ISSUE	DATE	DRAWN	CHECKED	DESCRIPTION
DRAWING TITLE		GA PROPOSED SECTION C-C		
DRAWING NO.		CTH-PUR-MP-ZZ-DR-A-92202		
REVISION		P04		
SIZE & SCALE		A1L	1:200	
DRAWING STATUS		S4 - Planning

CLIENT	Lendlease	 PURCELL
PROJECT	Camden Town Hall	
JOB NUMBER	238664

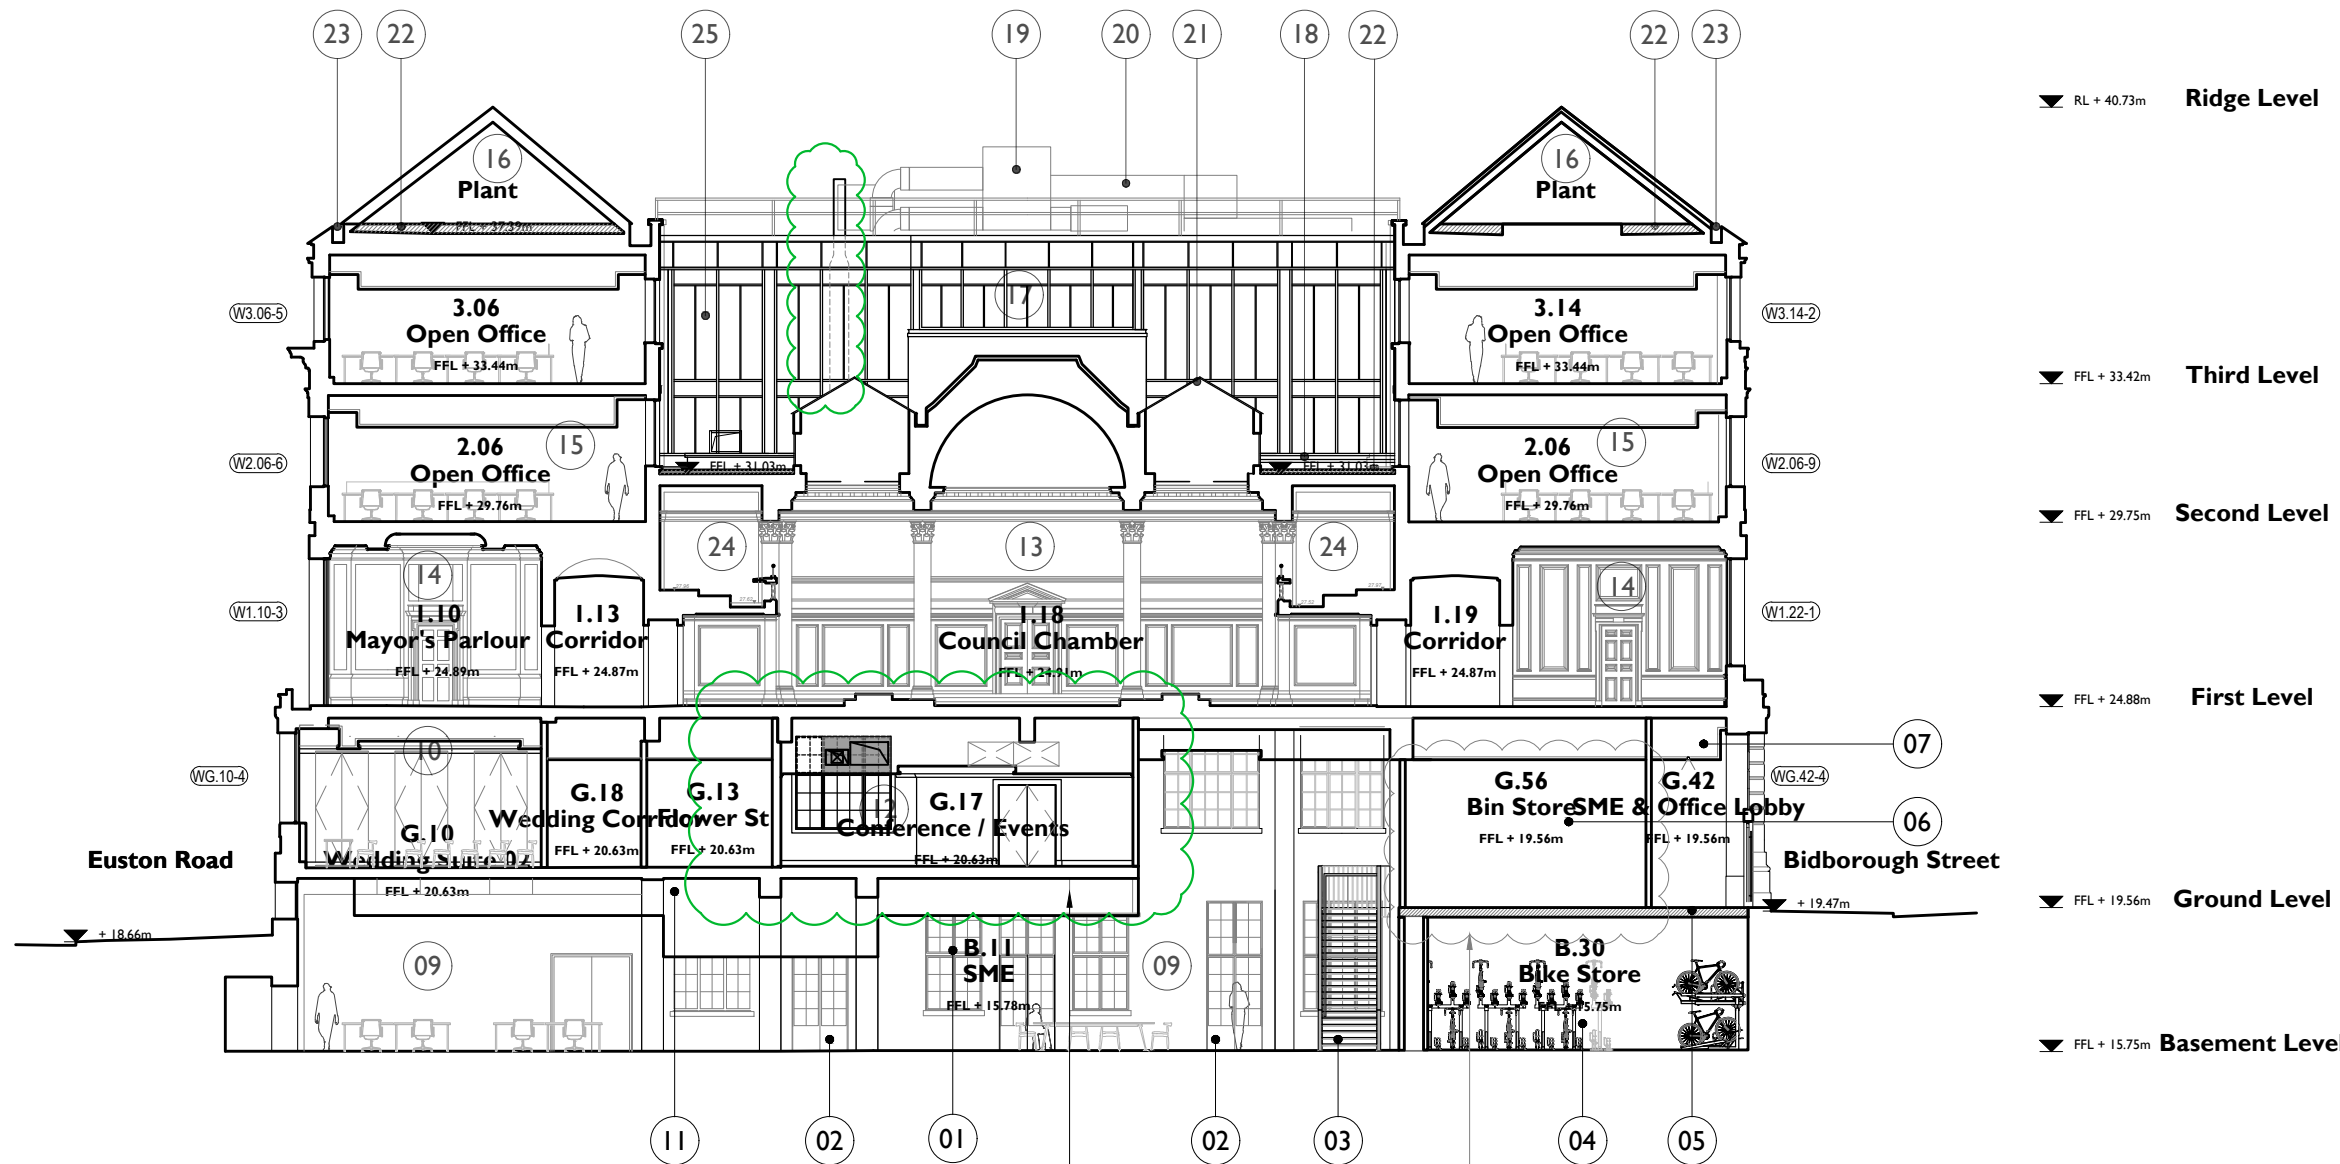
P04: Changes made to previous revision to incorporate Community room G.17 with relocated offices to room G.24.

Revision: Change to relocate BOH offices to room G.24 and creation of community room incorporate community space

P03 - Previous NMA : Proposals submitted under application ref number:2020/3862/P & Listed Building Consent ref: 2020/3849/L
REVISION - Proposed Bin Store relocated to ground floor to improve access and reduce pull distance
